CDUA: MA-3543

October 28, 2010

**REGARDING:** After the Fact (ATF) Conservation District Use Application  
(CDUA) MA-3543 for Hale Kai AOA Seawall

ATTACHMENT 13. REVISED Exhibit "B" INDICATING ACTUAL 1998 BOULDER REPAIR WORK AND 2004 CEMENT (WALL) REPAIR WORK

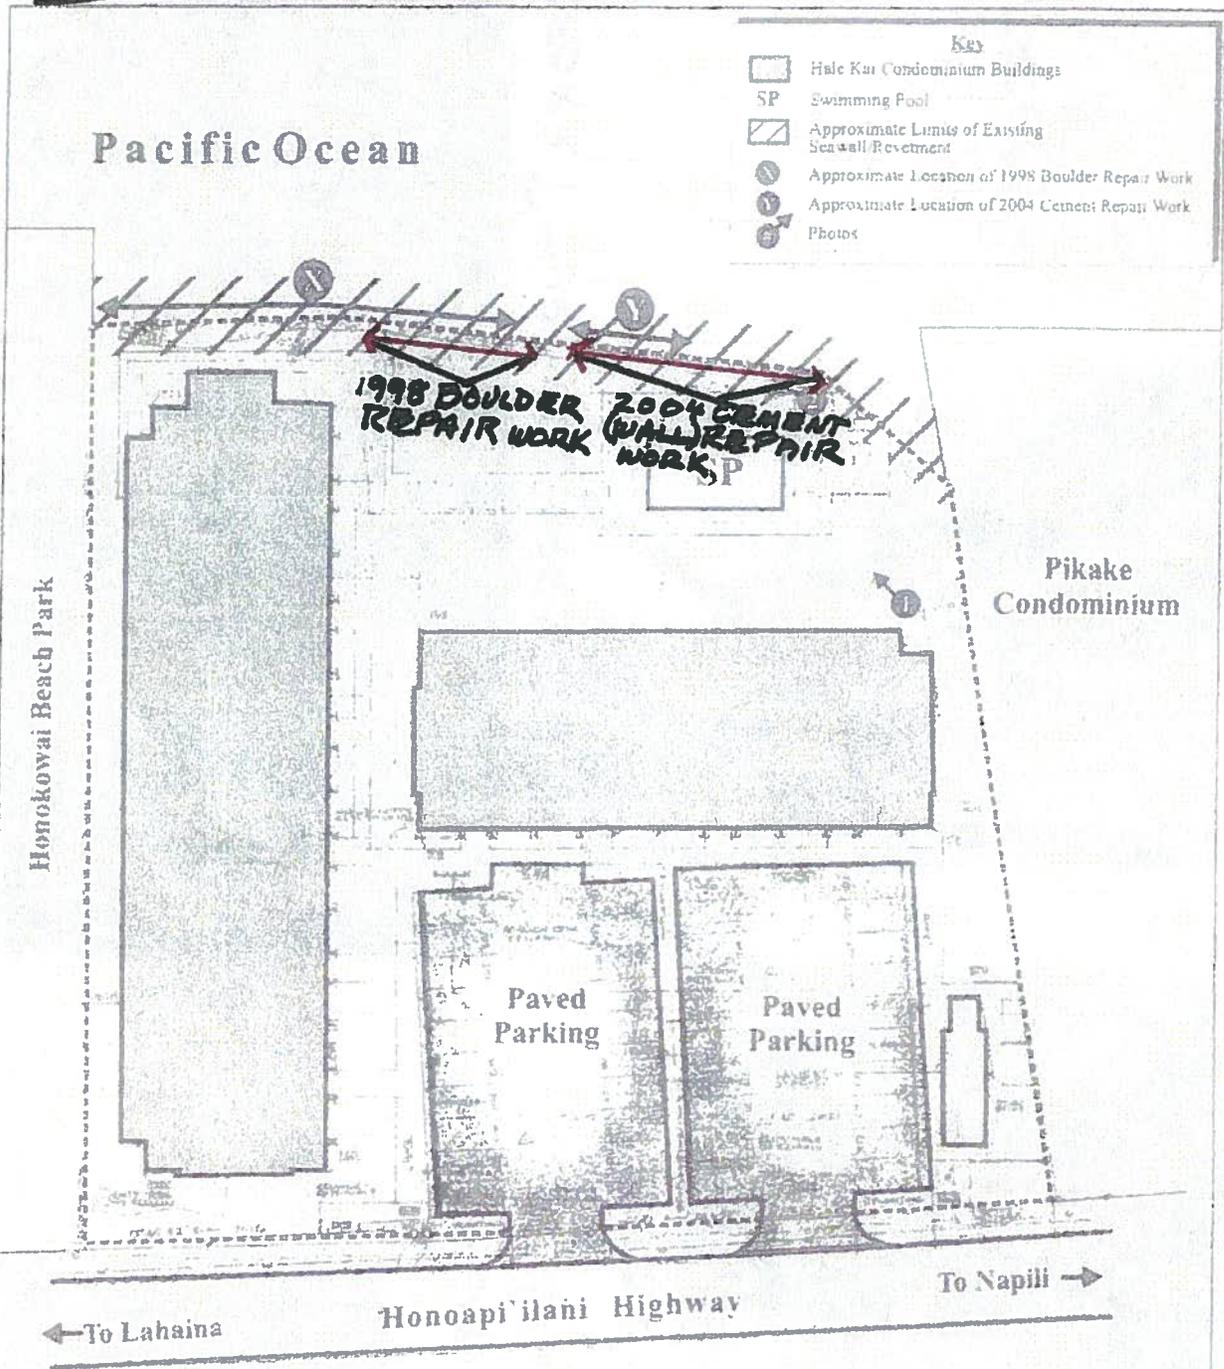
Exhibit "B" is incorrect and misleading. See ATTACHMENT 13. REVISED Exhibit "B". The actual location of the 1998 BOULDER REPAIR WORK and 2004 CEMENT WALL REPAIR WORK is shown.

*Exhibit "B" is incorrect and misleading. See ATTACHMENT 13. REVISED Exhibit "B". The actual location of the 1998 BOULDER REPAIR WORK and 2004 CEMENT WALL REPAIR WORK is shown.*

As noted previously, the figures presented the Draft EA have been revised to clarify the location of the 1998 boulder repair work and the 2004 cement repair work.

ATTACHMENT  
1. A.

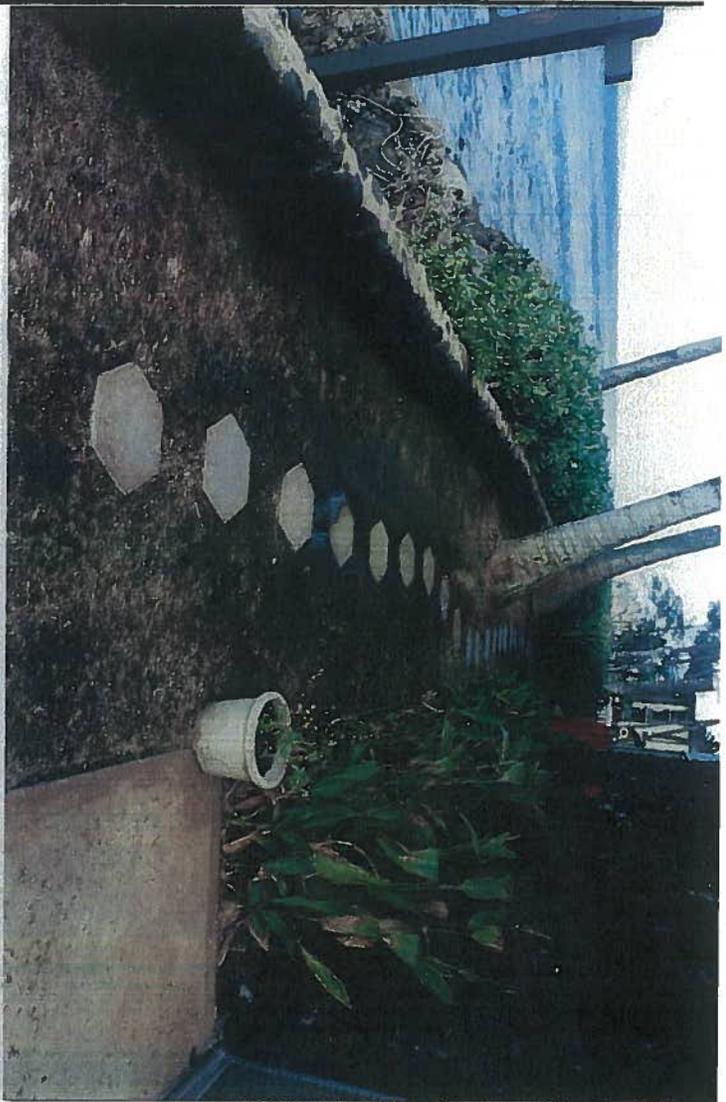
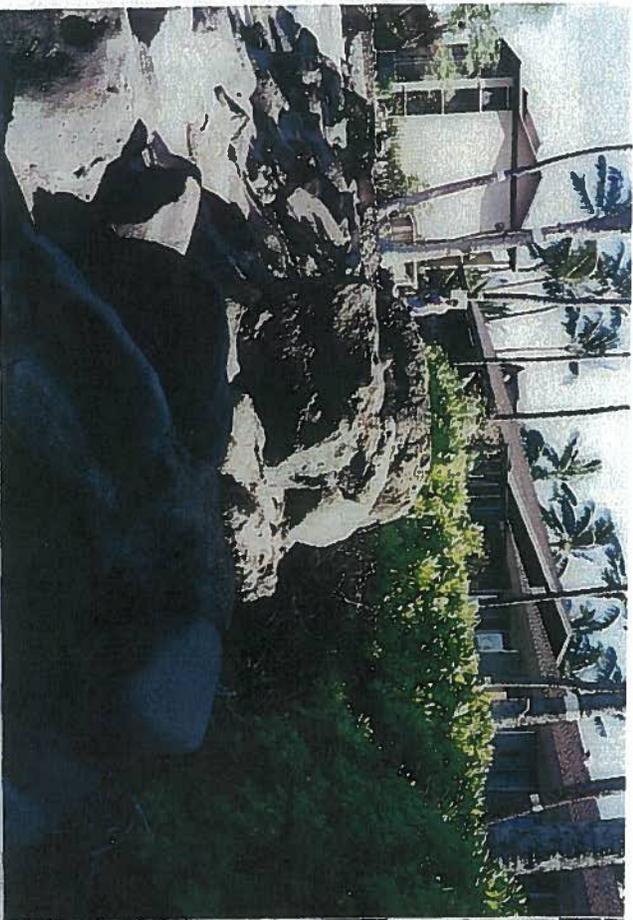
See: ATTACHMENT 1.A The photos, lower left and upper right "During 1993 Repairs" show the wall repair and "Gravel and Geotextile Filter" construction on the building side of the wall as approved in the January 1993 SMA/SS approval, not seaward side of the wall as shown in Figure 1. Photo upper left is before 1993 repair, photo lower right is after 1993 repair.

*See: ATTACHMENT 1.A The photos, lower left and upper right "During 1993 Repairs" show the wall repair and "Gravel and Geotextile Filter" construction on the building side of the wall as approved in the January 1993 SMA/SS approval, not seaward side of the wall as shown in Figure 1. Photo upper left is before 1993 repair, photo lower right is*

We acknowledge the information provided on the repairs that were undertaken in 1993 by the Hale Kai AOA to a garden wall on the property that runs along the mauka side of the top of the existing seawall/revetment. An SMA approval was issued in 1993 by the County of Maui, Department of Planning prior to the completion of this work, which is separate and distinct from the 1998 boulder repair work and 2004 cement grouting repair work that is the subject of the CDUA currently being processed by OCCL.

ATTACHMENT  
1. H.

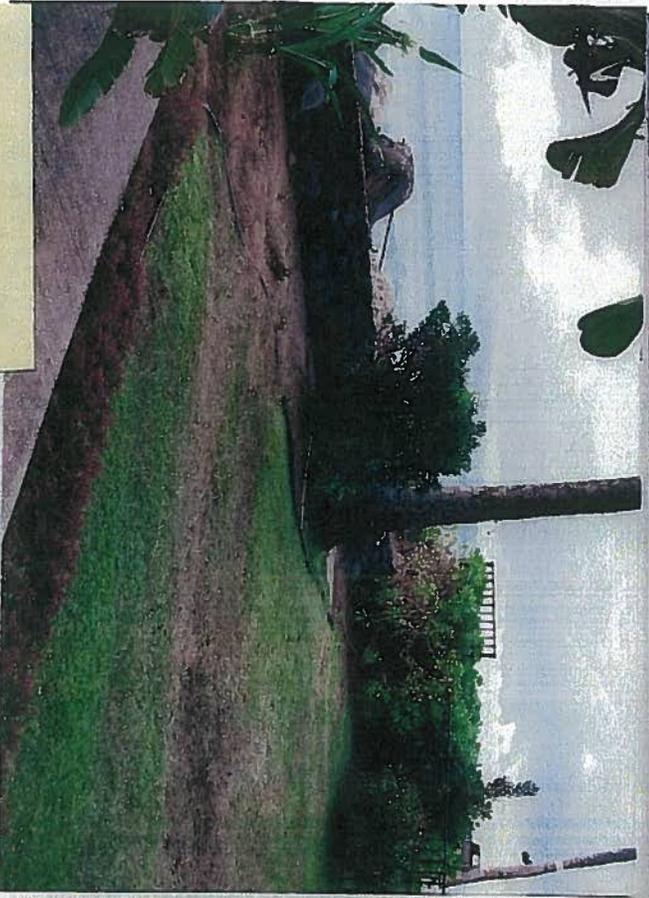
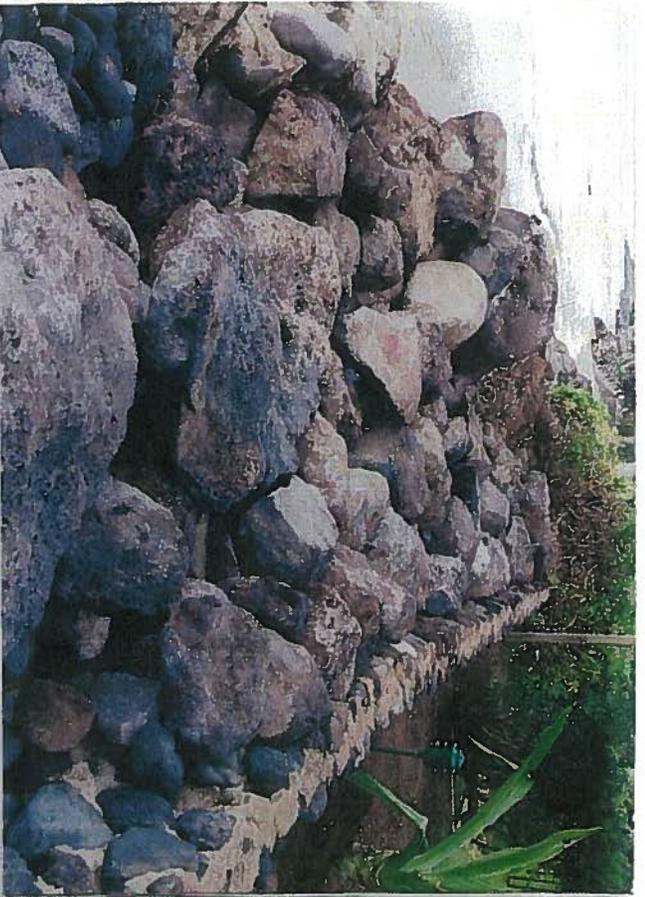
Figure 5. is misleading. As shown in ATTACHMENT 1. H. the rocks are to the top of the wall. There is some erosion caused by the drainage of the ocean water that collected behind the wall, flowing south beyond the pool fence. The erosion under the pool fence extends north approximately four (4) feet. See ATTACHMENT 4. PHOTOS OF POOLING OCEAN WATER BEHIND SEAWALL AND PHOTOS OF EROSION UNDER POOL FENCE.

*Figure 5. is misleading. As shown in ATTACHMENT 1. H. the rocks are to the top of the wall. There is some erosion caused by the drainage of the ocean water that collected behind the wall, flowing south beyond the pool fence. The erosion under the pool fence extends north approximately four (4) feet. See ATTACHMENT 4. PHOTOS OF POOLING OCEAN WATER BEHIND SEAWALL AND PHOTOS OF EROSION UNDER POOL FENCE.*

The photographs provided in Attachment 1-H illustrate the condition of the revetment (looking south towards Honokowai Beach Park) as it existed in 1998. The site inspection, referenced in the May 15, 2009 SEI memorandum, was conducted in 2007, almost ten (10) years later. Figure 5 of the SEI memorandum represents an accurate depiction of the condition of that particular 20-foot section of the revetment as it existed during the site inspection in 2007. Figure 5 is intended to show the condition of this section of the revetment before the Gravel and Geotextile Filter was installed in 2007, as recommended by SEI. Figure 6 of the SEI memorandum shows the intended design as recommended by SEI in 2007 while Figure 7 is a representation of the same section of the revetment as it appeared following completion of the repair work during a January 2009 inspection by SEI. The May 15, 2009 SEI memorandum details a corrective action to repair this section of revetment so that it is consistent with the design as recommended in Figure 6. A SMA Minor Permit and SSA has been obtained from the Maui Planning Department for the completion of this corrective action repair work. The precise scope of work for this corrective action is described in our response to Comment No. 8 below.

In regards to the comment on drainage, Mr. Newton is correct in the statement he makes that there is occasionally ponding of sea water experienced along the mauka side of the revetment/seawall structure during periodic high wave events, which predominantly occur during the winter months. This is typical of most shoreline properties along the Kaanapali coastline. The various improvements that have been undertaken over the years by the Hale Kai AOA to the existing seawall/revetment structure have been completed with the intention of addressing these wave-related erosion issues and protecting the health and safety of residents at the Hale Kai property.

Figure 6. Recommended gravel filter repair

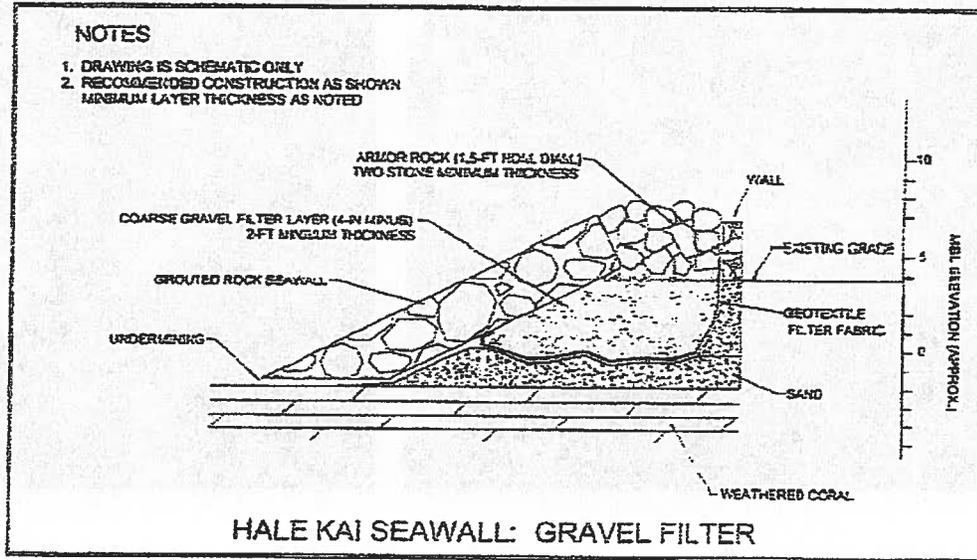
The recommended corrective action is to modify the crest to comply with the schematic representation shown in Figure 6. As follows:

- Remove the crest stones
- Excavate gravel 3 feet down below the crest
- Fill the excavation with stones approximately 1.5 ft. to 2 ft. in diameter.

The corrective action that should be undertaken for this area is to dig down to weathered coral, install a sand base, line the trench with filter fabric, fill with gravel to existing grade, then fill with stones to wall height as shown in Figure 6.

*The recommended corrective action is to modify the crest to comply with the schematic representation shown in Figure 6. As follows:*

- Remove the crest stones*
- Excavate gravel 3 feet down below the crest*
- Fill the excavation with stones approximately 1.5 ft. to 2 ft. in diameter.*

*The corrective action that should be undertaken for this area is to dig down to weathered coral, install a sand base, line the trench with filter fabric, fill with gravel to existing grade, then fill with stones to wall height as shown in Figure 6.*

We have also consulted with our coastal engineer (SEI) regarding Mr. Newton's comment on the preferred design for the crest stone replacement work as defined in the May 15, 2009 memorandum. The corrective action as recommended by Mr. Newton is similar to the design recommended by SEI. SEI does not recommend excavating down to the limestone substrate (weathered coral), as information concerning the nature and elevation of the substrate is not extensive. The gravel and geotextile filter is designed to respond to any settlement that may occur below the filter and will act as a plug to minimize hydraulic action. The geotextile layer will also serve to protect the substrate behind the revetment (below the existing garden wall). The resulting structure, as recommended in the May 15, 2009 SEI memorandum, will be an improvement over the previous condition as observed during the 2007 site inspection.

Figure 7. Condition of repaired revetment, January 2009

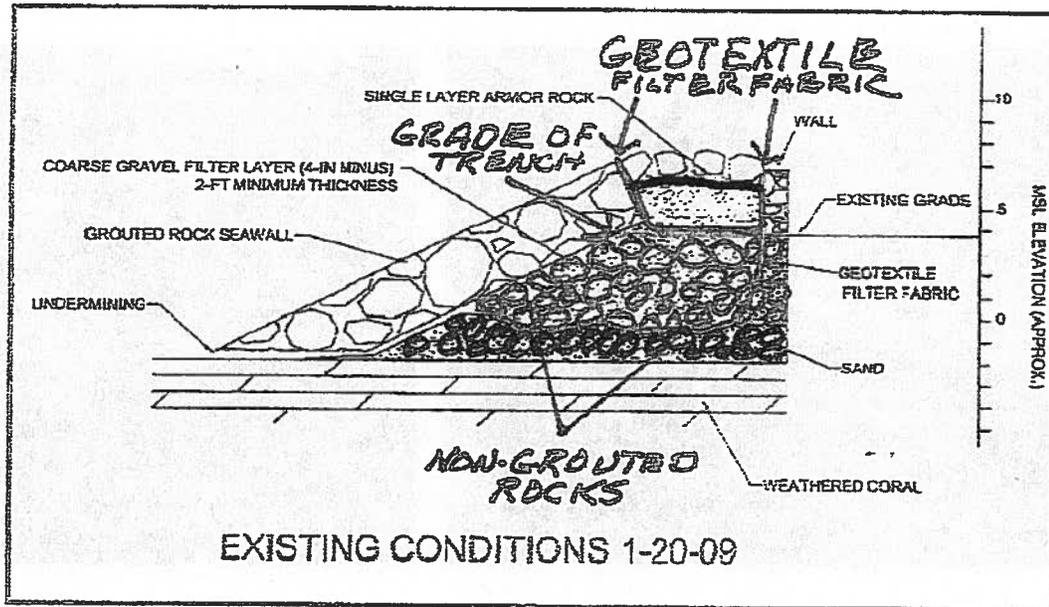
Figure 7. is misleading and incorrect.

*Figure 7. is misleading and incorrect.*

As noted previously, a SMA Minor Permit and SSA was recently issued (in March 2010) by the Maui Planning Department for this corrective action repair work. Hale Kai will be proceeding with the crest stone replacement work upon completion of the CDUA process for the 1998 boulder repair work and the 2004 cement grouting repair work.

ATTACHMENT 12.

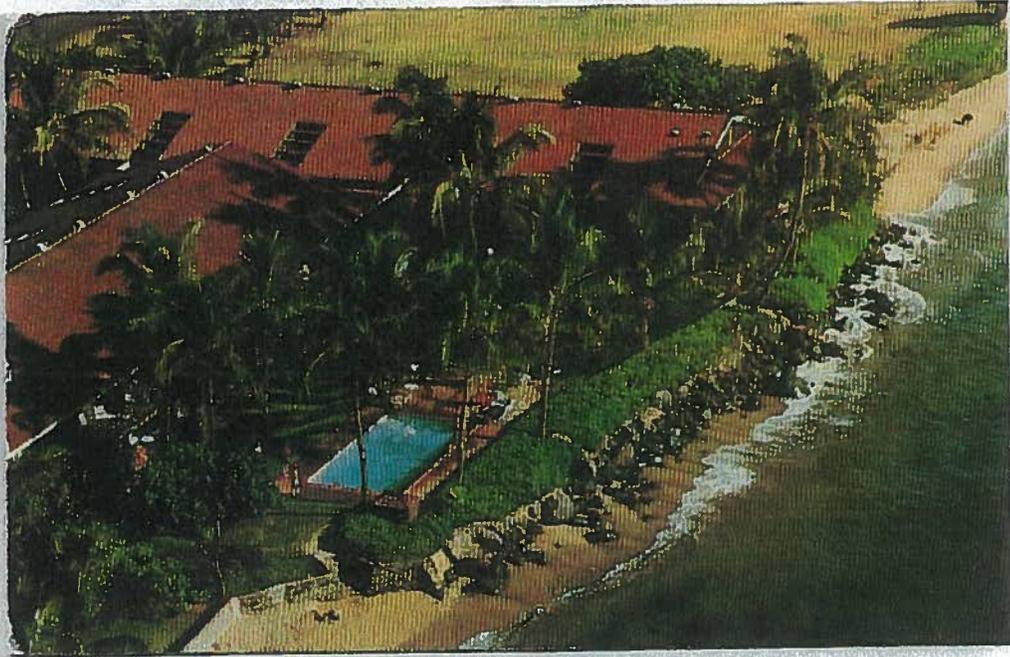
The solution is to go back to their roots. Prior to the vertical wall built in 2004 there were never 20 ft. overtopping waves. Remove the vertical wall built in 2004, which will allow the waves to flow back into the ocean as it has been doing for since 1966. (\* see Note ATTACHMENT 11.) Then plant naupaka along the oceanfront of the property as shown in ATTACHMENT 12. NAUPAKA OCEANSIDE BEFORE VERTICAL WALL.

*The solution is to go back to their roots. Prior to the vertical wall built in 2004 there were never 20 ft. overtopping waves. Remove the vertical wall built in 2004, which will allow the waves to flow back into the ocean as it has been doing for since 1966. (\* see Note ATTACHMENT 11.) Then plant naupaka along the oceanfront of the property as shown in ATTACHMENT 12. NAUPAKA OCEANSIDE BEFORE VERTICAL WALL.*

We have consulted with SEI regarding Mr. Newton's comments regarding the effects of the raising of the seawall as completed in 2004. We have been informed that while the additional vertical height of seawall along the swimming pool may direct wave impact and ocean spray more skyward, it also proves effective at blocking direct wave overtopping. Lowering the wall (as suggested in Mr. Newton's comment letter) will increase, not decrease the potential for wave overtopping to occur along the seawall/revetment structure.
